Granville Road

**Design & Access Statement
Addendum**

December 2014

Client
Mulalley/One Housing Group

Revised Landscape Masterplan drawing 2928A/D/900/P4

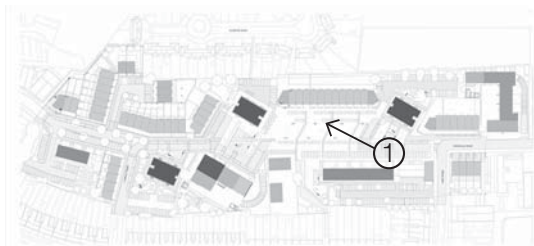
drawing		proposed amendment
2928a D/900/P4	Landscape Site plan	Amended to take into account changes documented elsewhere
2928a D/901/P10	Coloured Landscape site masterplan	Amended to take into account changes documented elsewhere
2928a D/902/P4	Hardscape plan	Amended to take into account changes documented elsewhere
2928a D/903/P7	Boundaries plan	Changes made in line with Crime Prevention Design Advisor comments <ol style="list-style-type: none"> 1. Second secure boundary added to mouth of car parks 2. Redesign of boundary treatment between Block C and Templewood point 3. Redesign of boundary at top of Block A car park ramp 4. Additional boundary treatment to Block C boundary with neighbouring Aphrodite.
2928a D/904/P5	Tree Protection & Retention Plan	Trees retained amended to match PJC report. Numbers showing of trees retained & proposed omitted from plan - refer to PJC report for accurate numbers. Trees flagged as being hard to retain have been omitted. Minor amendments in line with tree officer comments
